UNITED STATES PATENT AND TRADEMARK OFFICE

APPLICATION NO.	FILING DATE	FIRST NAMED INVENTOR	ATTORNEY DOCKET NO.	CONFIRMATION NO.
10/679,266	10/07/2003	Prasad Mantri	M4065.0910/P910	3128

Office Action Summary

DETAILED ACTION

FIG. 1 (PRIOR ART)

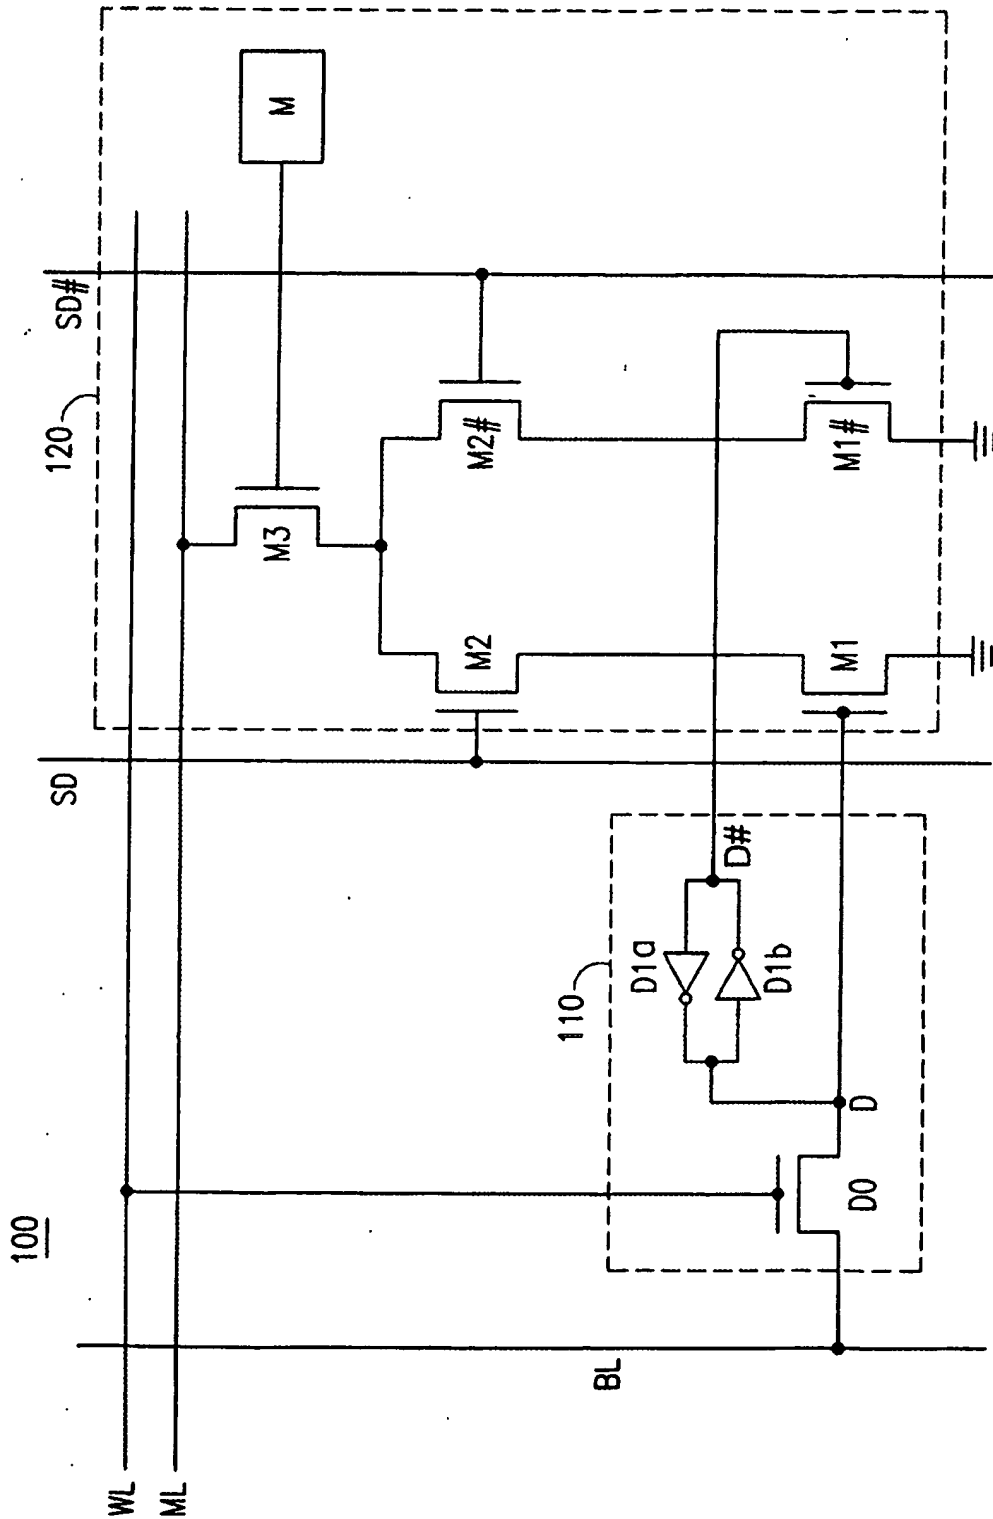
The examiner withdraws the objection to FIG. 1 and approves entry into the record of the revised drawing.
